To: T10 Technical Committee
From: Rob Elliott, HP (elliott@hp.com)
Date: 11 December 2003
Subject: T10/03-337r3 SPC-3 Third party persistent reservations

Figure 1. Third-party copy

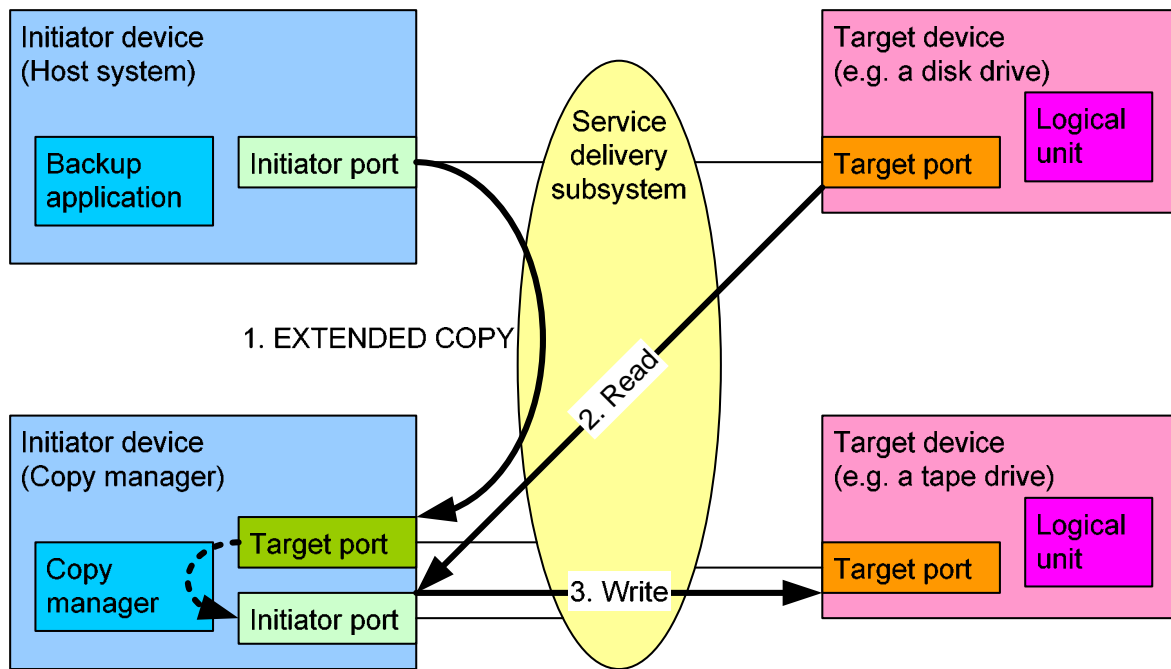
Classic RESERVE/RELEASE reservations included a third-party reservation feature that let one initiator port hand over its reservation to another initiator port. This is useful for third party copy managers (EXTENDED COPY). However, this feature is not available in persistent reservations.

03-233 proposed a MOVE service action, specifying the reservation key to move. However, this isn't precise enough if more than one I_T is registered with the same reservation key. The Specify Initiator ports feature can be used to fix this.

Figure 2. Third party persistent reservation

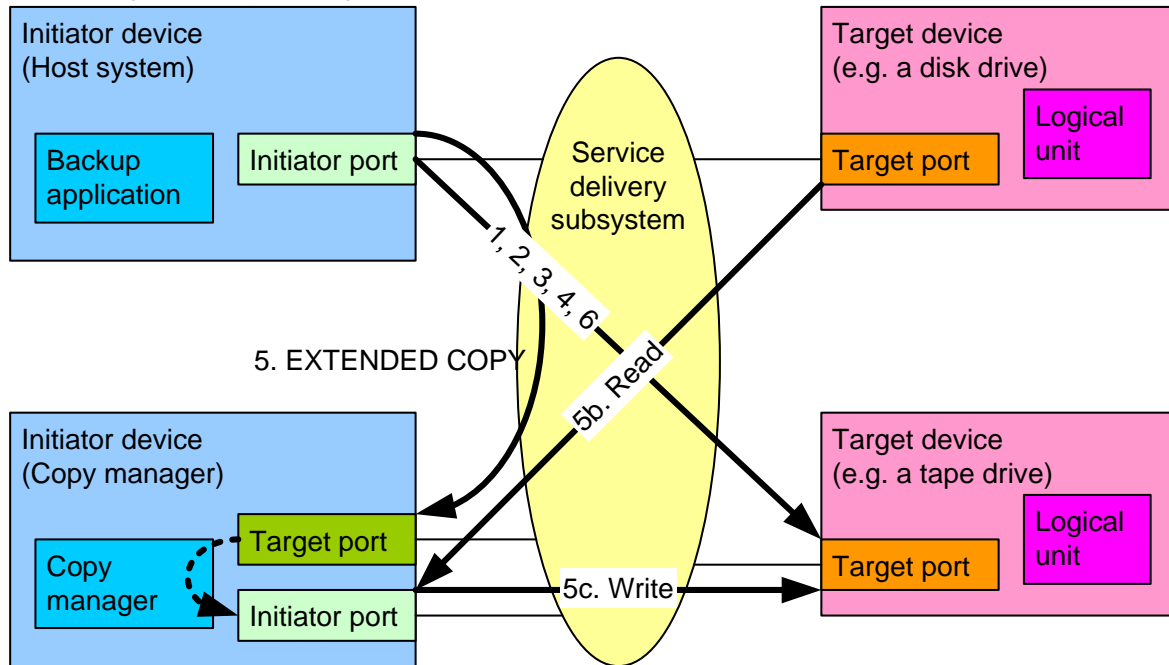
Add a REGISTER and MOVE service actions to both register a specified I_T nexus and move the existing reservation to it, all in one step. Add Specify Initiator Ports functionality to PREEMPT to take back the reservation from a specific I_T nexus.

After it has become a reservation holder through an I_T, the backup application uses a PERSISTENT RESERVE OUT command REGISTER AND MOVE service action with:

- SPEC_I_PT bit set to 1
- parameter data specifying the copy manager's initiator port (exactly one TransportID)
- SERVICE ACTION RESERVATION KEY set to a reservation key for the copy manager
- RESERVATION KEY set to its own reservation key (normal rules for these service actions)

to move its current persistent reservation to the specified initiator port.
